## Consultant Notes from Public Meeting - First Settlement

**From:** [Jason Tish](#)  
**To:** [Jennifer Lehrke](#)  
**Cc:** [Scanlon, Amy](#); [Fruhling, William](#)  
**Subject:** HPP – Round 3 HD meeting, First Settlement – Dec. 13, 2018  
**Date:** Thursday, December 13, 2018 6:55:47 PM

# Ordinance Recommendations

## Historic Preservation Project

**Figure 1: The Dowling Building and the Lake Park Apartments on West Wilson Street.**

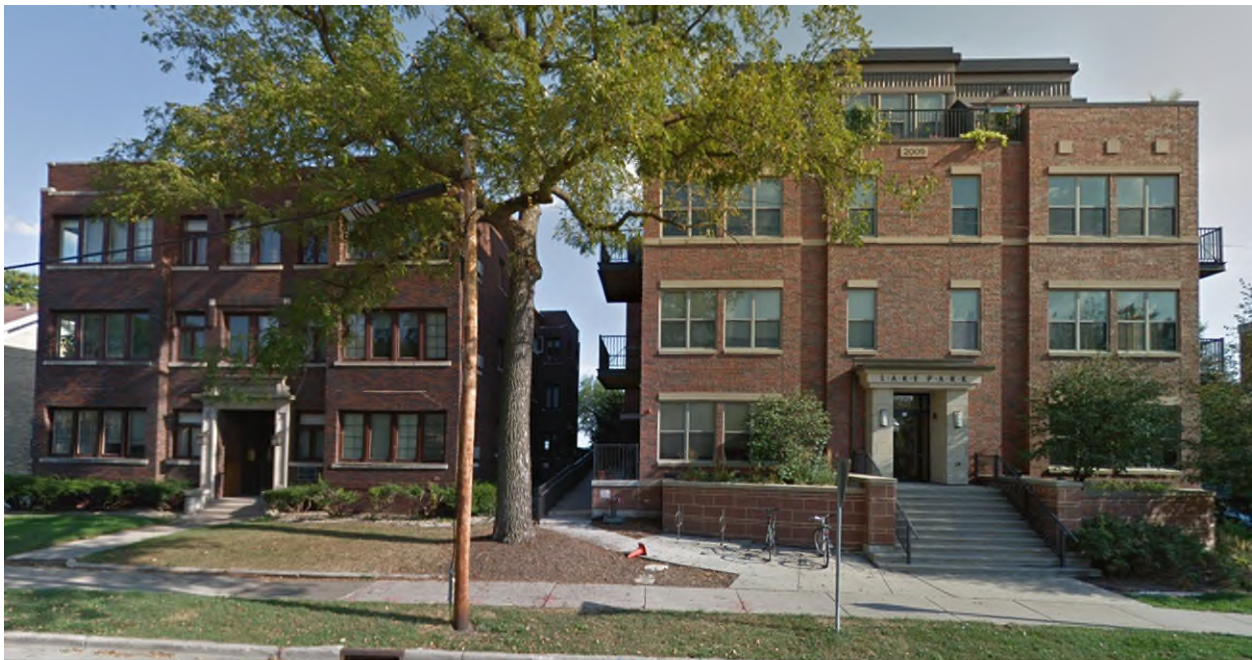
- Page 22, 7<sup>th</sup> bullet point: The requirement for infill structures to be compatible with the size and scale of surrounding buildings should be clarified so it does not limit structures that are larger than existing buildings. New structures can be built to be visually compatible with existing buildings while allowing a larger square footage (*e.g.*, Lake Park Apartments next to the Dowling Building on West Wilson Street—see Figure 1).
